MILWAUKIE

Date: May 21, 2010, for May 25, 2010, Public Hearing

Subject: Files: DR-09-01, TPR-09-03, WG-09-01, WQR-09-01, VR-09-03

PROJECT
**MILWAUKIE RIVERFRONT PARK
 PARK IMPROVEMENT PROJECT**
 S.E. HARRISON STREET - KELLOGG CREEK

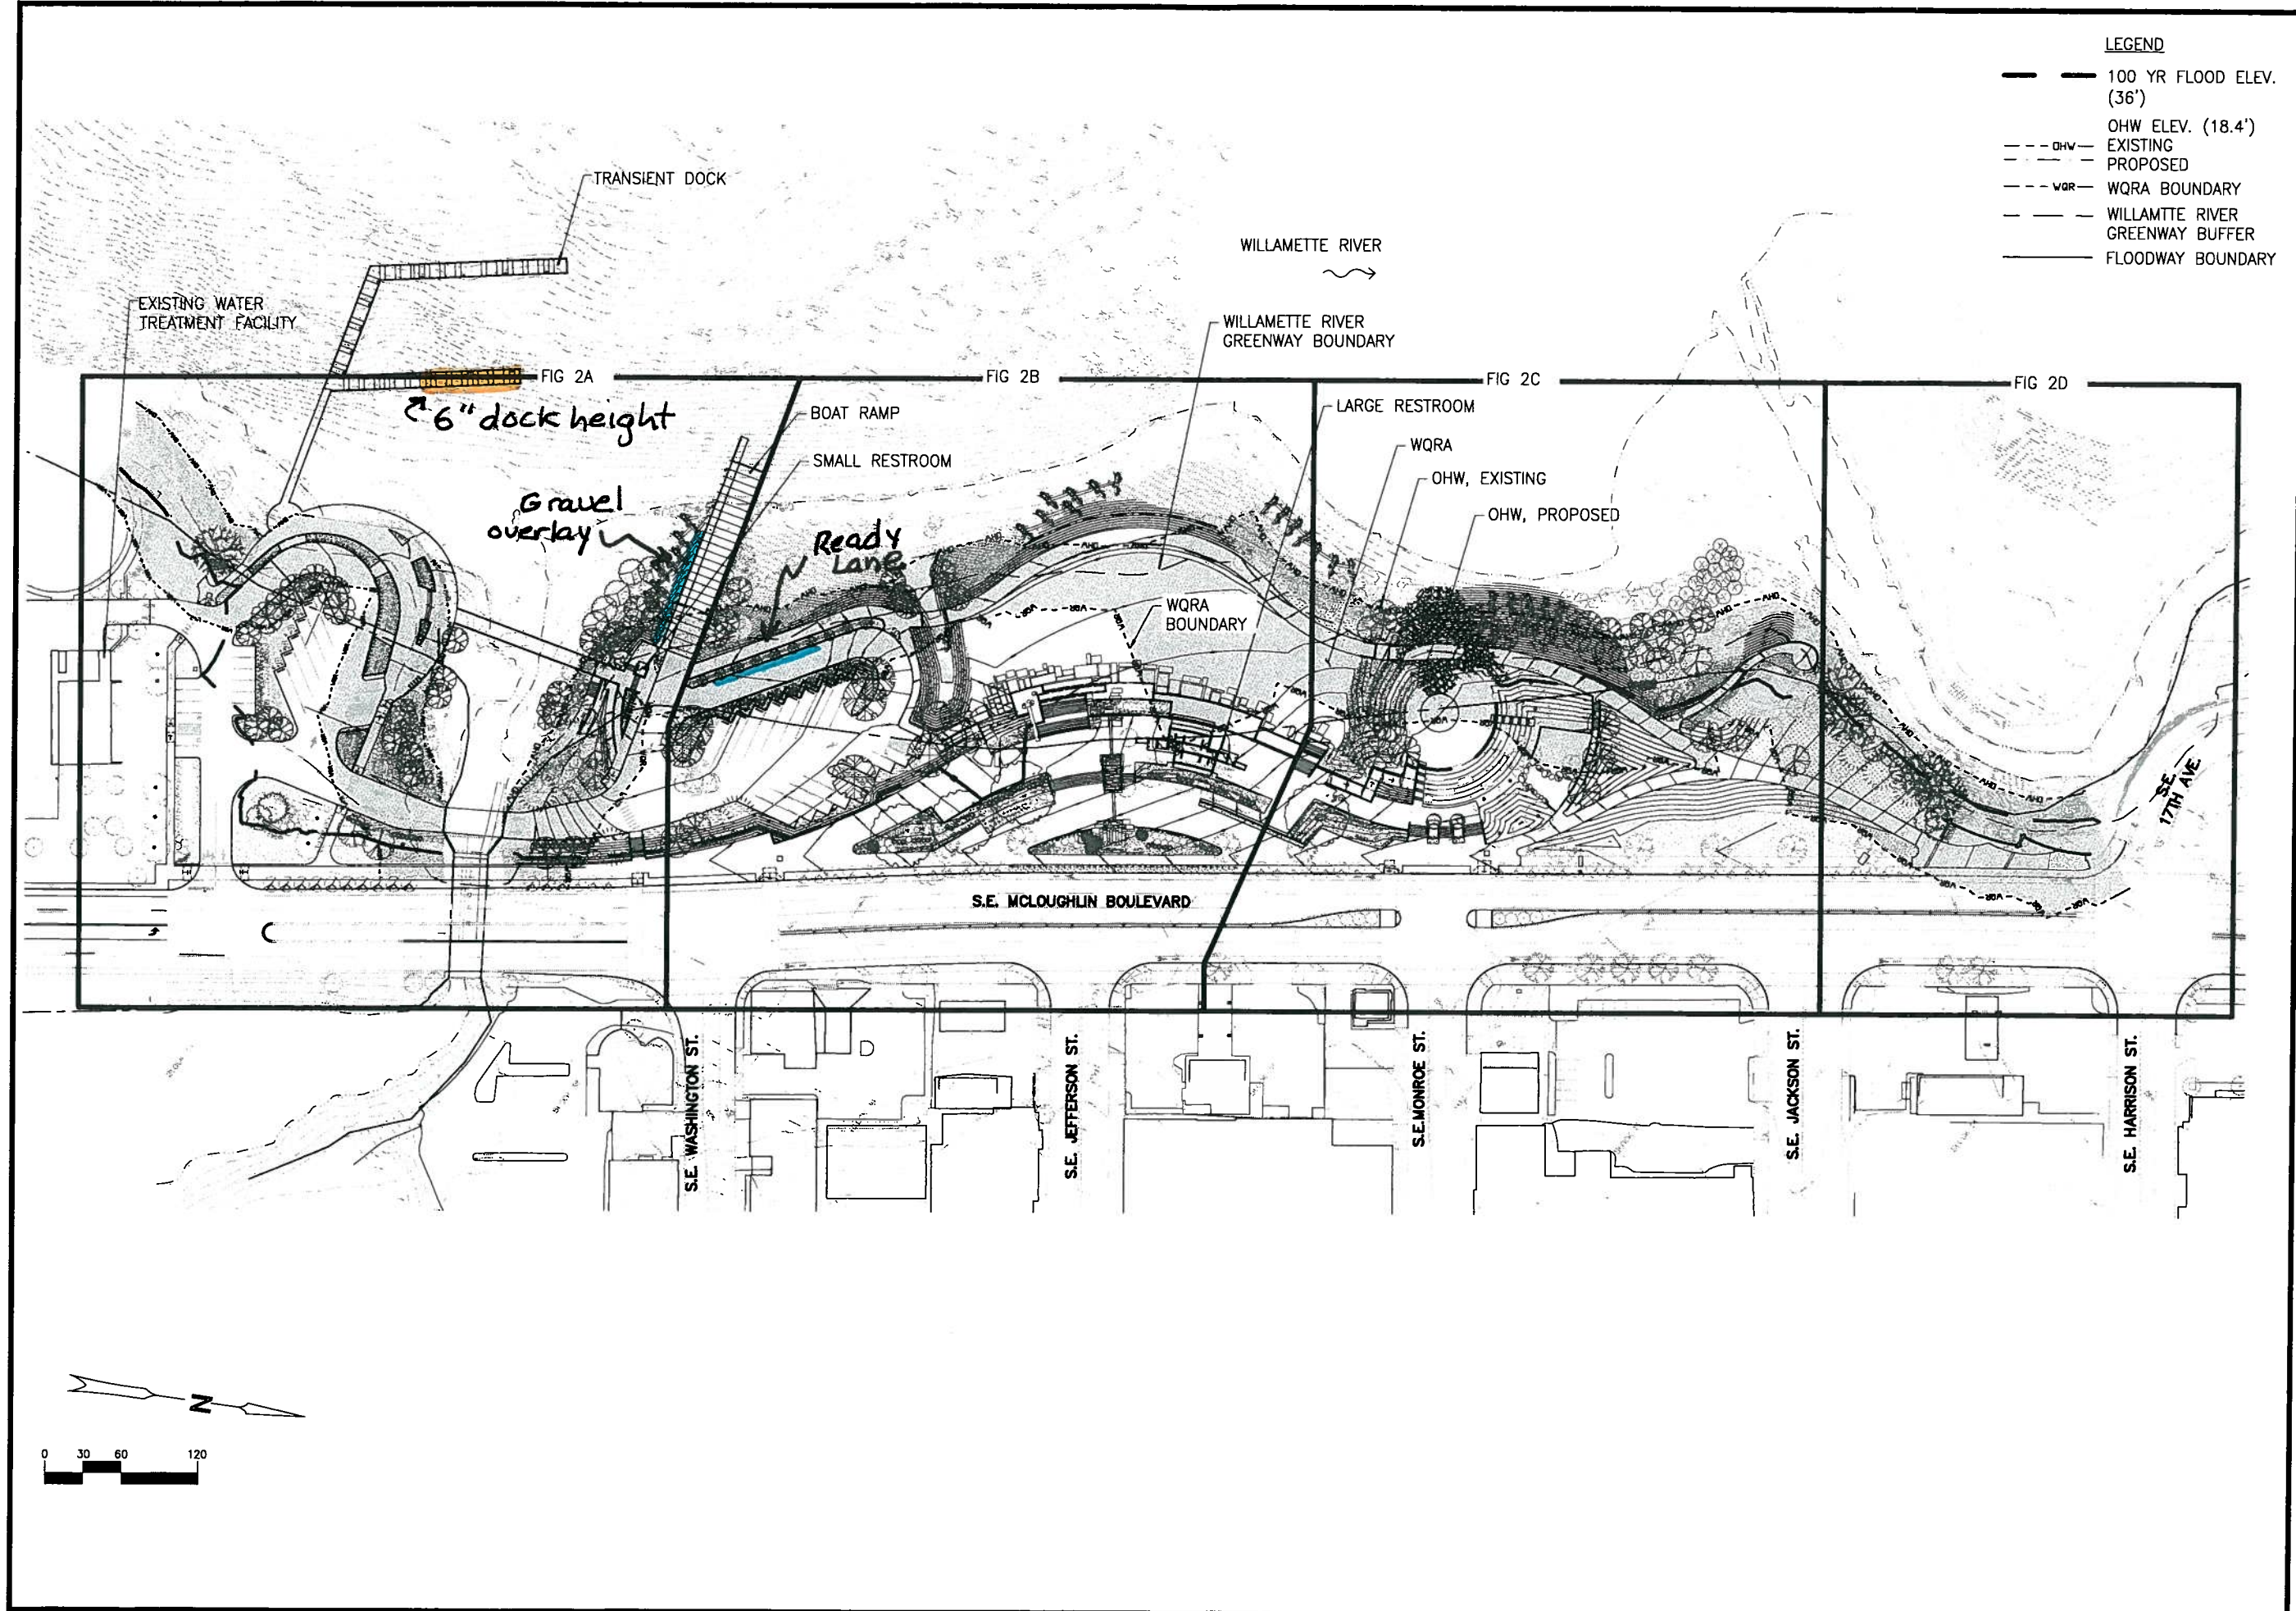
- **Do not modify the plan in any way and allow use of the boat ramp, boarding dock and transient dock by both motorized and non-motorized boaters.**
- **Modify the height of all or part of one of the forks of the transient dock to accommodate non-motorized boats.** The current height of the transient dock is 18" above the water. Lowering part of or all of one fork of this dock to 6" above the water level would make kayak, canoe and dragon boat access much easier. This type of dock is currently used by non-motorized boaters on the east side of the Willamette River just north of OMSI, in Portland. The access ramp to this Portland dock is, in fact, steeper than the ramp proposed for Milwaukie Riverfront Park (3:1 vs 4:1 as proposed in Milwaukie.) The

- **Add a gravel overlay to the boulders currently proposed to the south of the motorized boat access dock.** The addition of a layer of gravel to the area to the south of the motorized boat launch dock would accommodate kayaks, canoes and dragon boats without requiring significant changes to the Riverfront Park design.

This option would require a small parking and staging area, called a “ready lane”, on the river side travel lane of the parking lot which would allow users to park and unload and stage their paddle craft and then go park their car in the parking area. They would return and launch their boats upstream (south) of the dock on the gravel launch area. Alternatively, they could walk their craft down the dock and place it in the water. This separation would minimize potential conflict between users at time of launch and retrieval.
